The Moat Farm, The Street, Hinderclay, IP22 1HX

This document is in response to planning enforcement documentation EN/21/00838, received 2022/12/15 regarding the renovation and refurbishment of The Moat Farm. The following information is to outline works done on the above listed property and answer queries/concerns raised by the planning authority. Photo locations can be found in accompanying documents A-1003 and A-1004

Response to request for information received on 2022/12/15

Photo of existing - Taken from sales brochure 2021

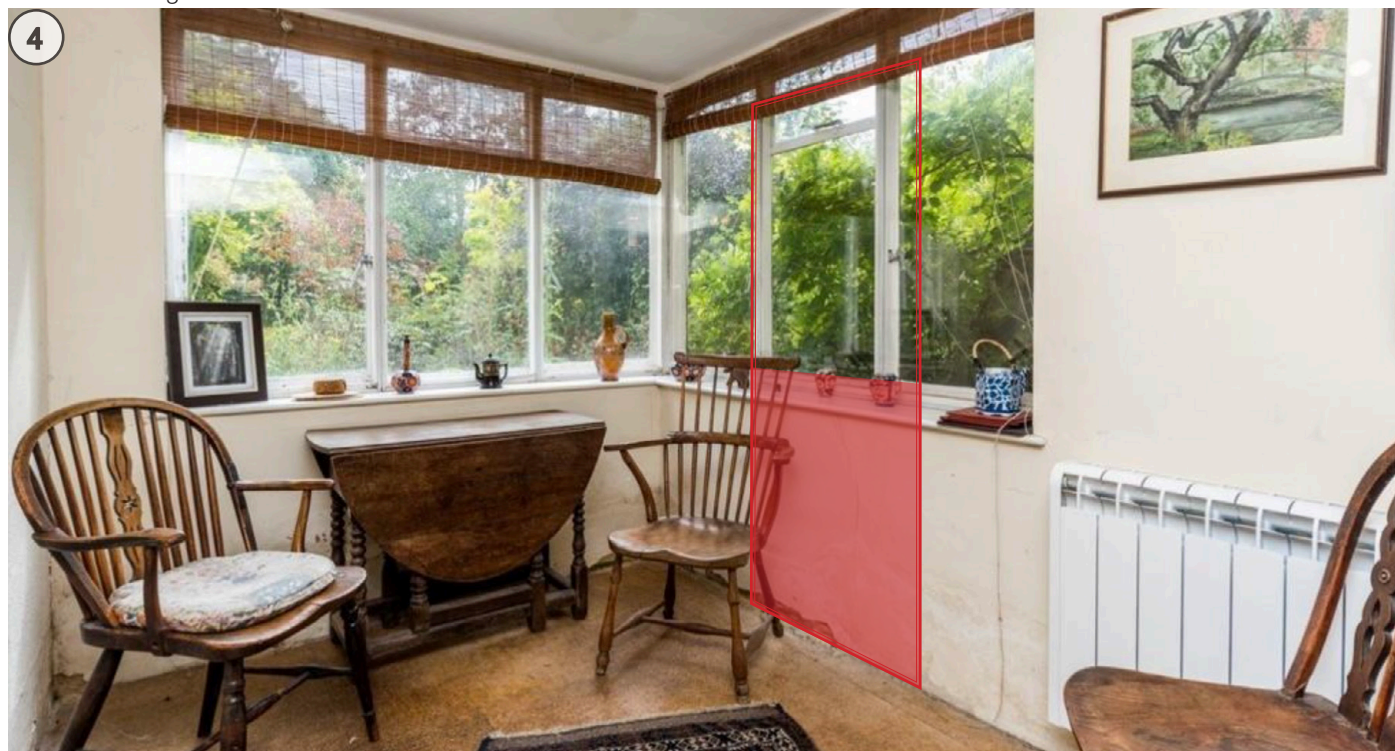
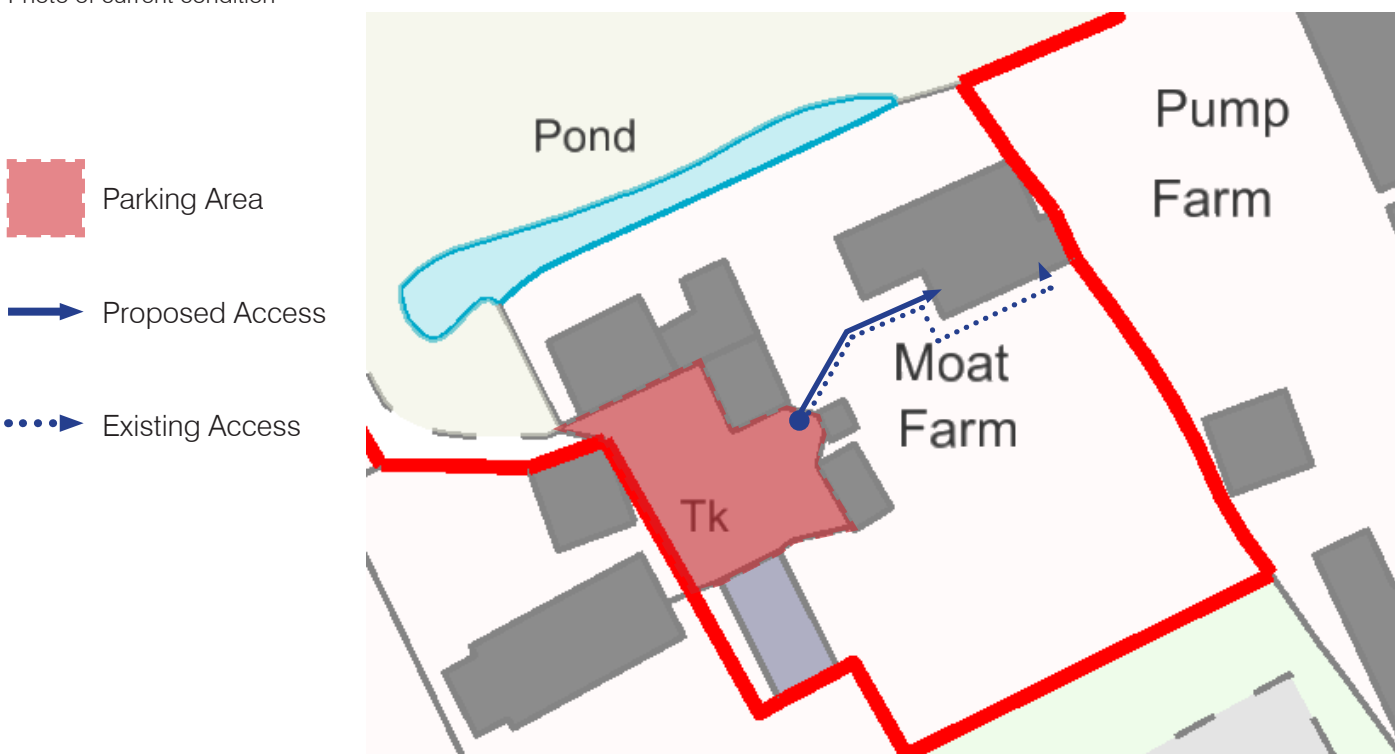
MD photo	LBC needed	support	comment	Summary Response
REAR EXTENSIONS					
Replace corner window extn with door and window	31, 36, 46	Y	Y		Evidence of existing doorway during repairs, decision made to reinstate

During repairs of the C20 SW extension walls and windows evidence was uncovered in the masonry that there had previously been external access. It was decided to restore this route as it created a more direct link to the external parking area and a more natural access point to the property.

Photo of current condition

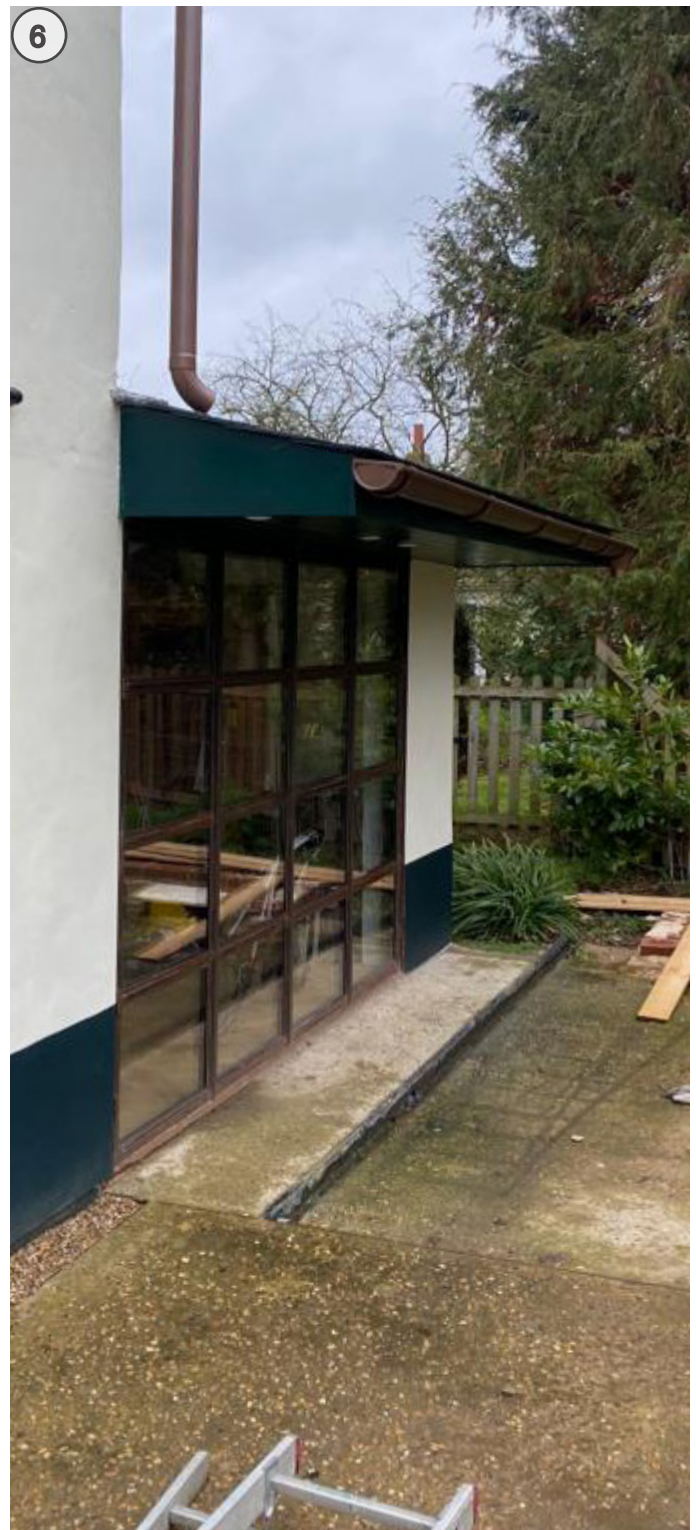
MD photo	LBC needed	support	comment	Summary Response
REAR EXTENSIONS					
Rear porch overhang of s/s roof	31, 49	Y	Y		Installed during roof repair

Installed during the repairs of the SE C20 sloped roof. The overhang was built to provide additional solar shading to the glazed extension as well as protection from the elements when the doors are in use.

Photo of current condition - C20 SE Extension Render

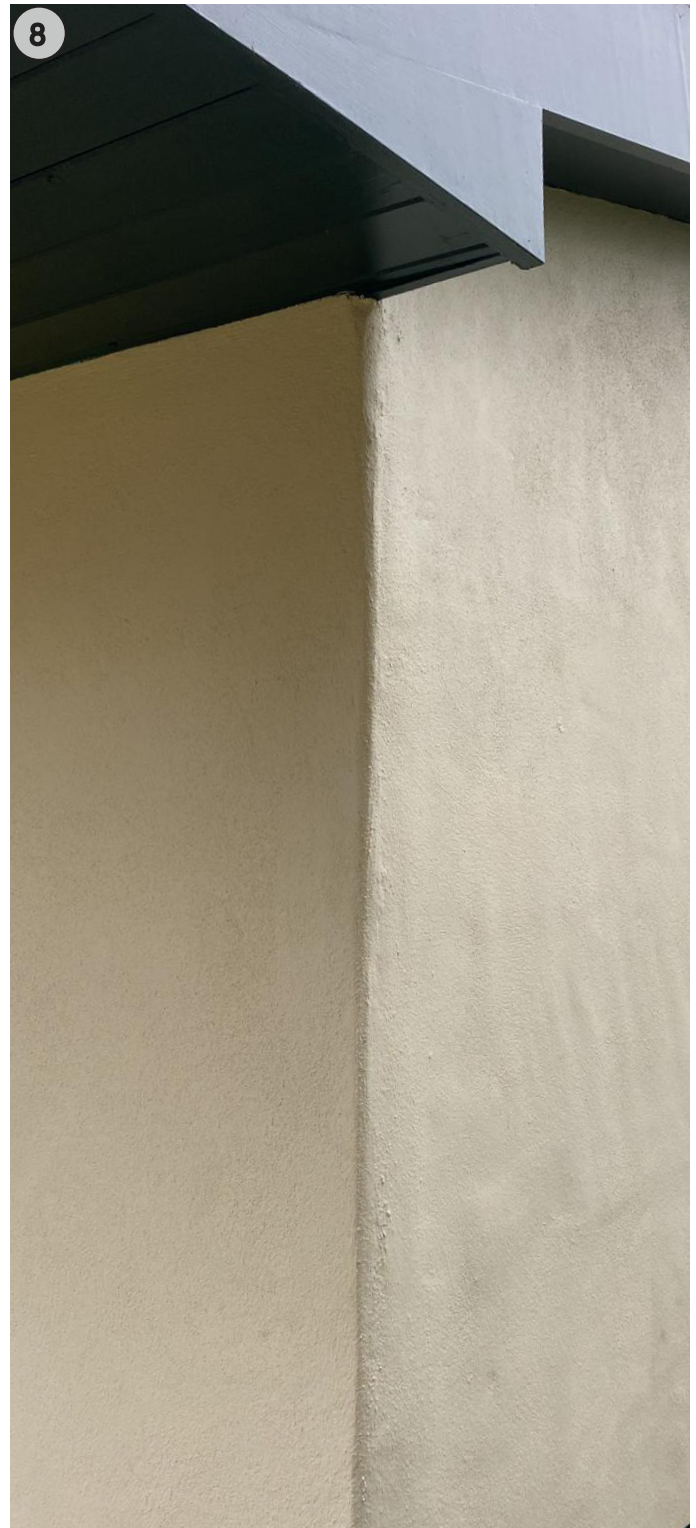
MD photo	LBC needed	support	comment	Summary Response
REAR EXTENSIONS					
Re-render s/s and 2/s extns	31	Prob N		Assume material is same as previous	Repaired due to water damage, materials match existing

Extension's rendering showed signs of water ingress and was beginning to crack and separate from the wall. Repairs were made where possible and re-rendered where necessary using materials to match the existing condition

Photo of existing - Taken from sales brochure 2021

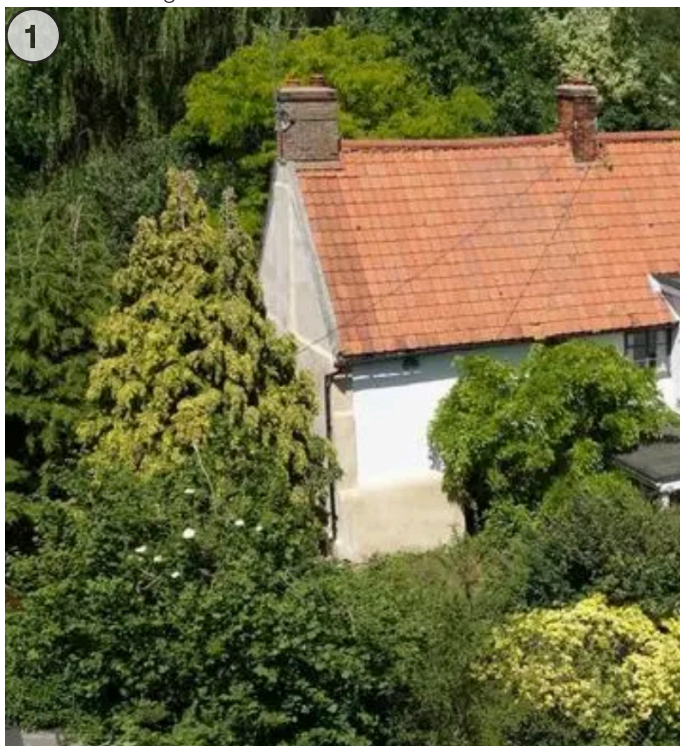
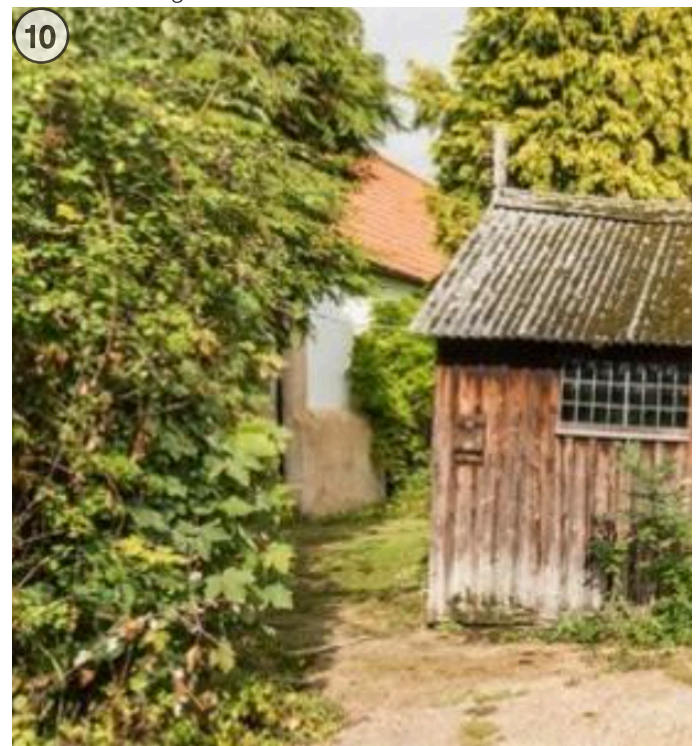
MD photo	LBC needed	support	comment	Summary Response
HISTORIC PART					
Render W gable and SW corner of S elevation; new barge boards and lead capping	31, 68	Y	N – should be lime; also needed for any timber repairs	This is possibly a brick gable, incorporating the large hearth, but the answer is the same.	Gable was rendered prior to ownership, new barge boards and lead capping replaced like for like.

W and SW gable were rendered prior to ownership, the assumption made that all prior works had been done using the correct historically accurate materials and in accordance with the listing.

Photo of existing - Taken from sales brochure 2021

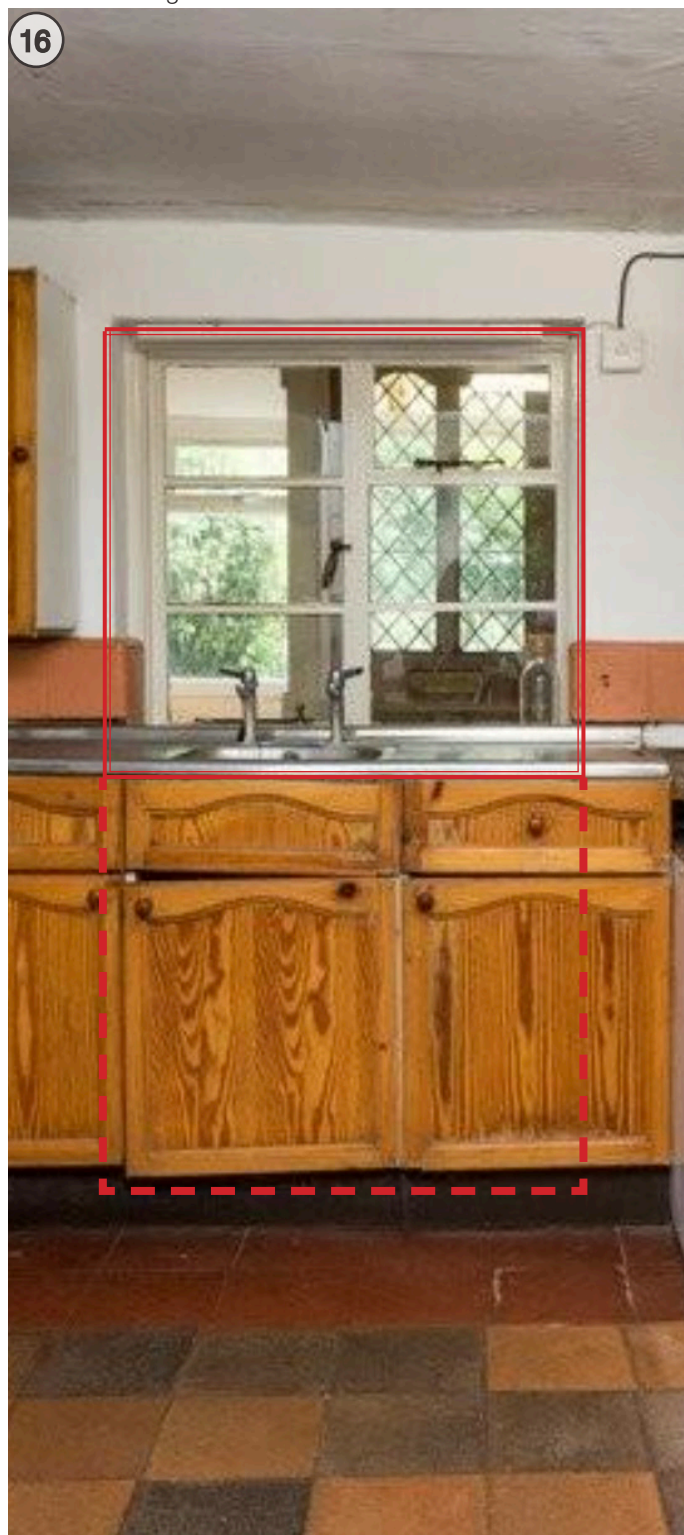
MD photo	LBC needed	support	comment	Summary Response
OTHER					
New door opening from porch to kitchen ?	36, 46, 50, 108	Y	Probably N	potential loss of historic frame; refuse unless clear evidence it was a previous opening; reinstatement might not be desirable.	An existing window, decision to convert to doorway to after uncovering evidence of previous doorway/failing repair

Existing window opening. During reparations to wall multiple masonry infill patches were uncovered, difficult to determine if it was a previous doorway or poorly repaired. Decision was made to remove the failing repair and convert to a doorway to provide a direct link from the kitchen to the extension and improve natural light penetration.

Site Plan hi-lighting Building B

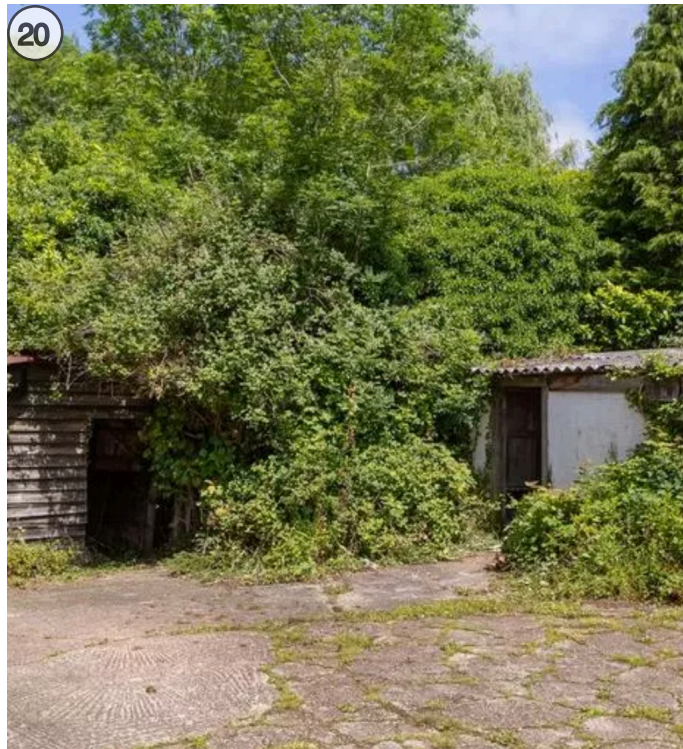
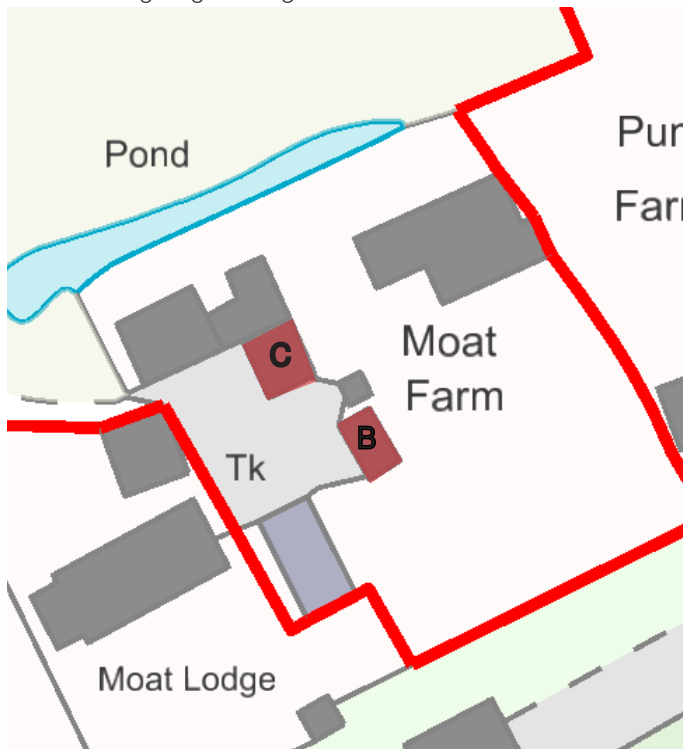
MD photo	LBC needed	support	comment	Summary Response
OTHER					
Old farm building with render above boards	82 etc			Potentially curtilage listed; hole in roof, fleeking	Outbuilding are untouched with the exception of 2 that suffered extensive damage

Existing outbuildings have not been subject to any renovation works with the except of building B and C, hi-lighted below both of which had suffered years of neglect and no maintenance. B collapsed after heavy winds and C's roof succumbed to extensive water damage resulting in collapse. At present the remaining outbuildings are being supported by external scaffolding to prevent further damage/risk of collapse and are being cleared of intrusive vegetation.
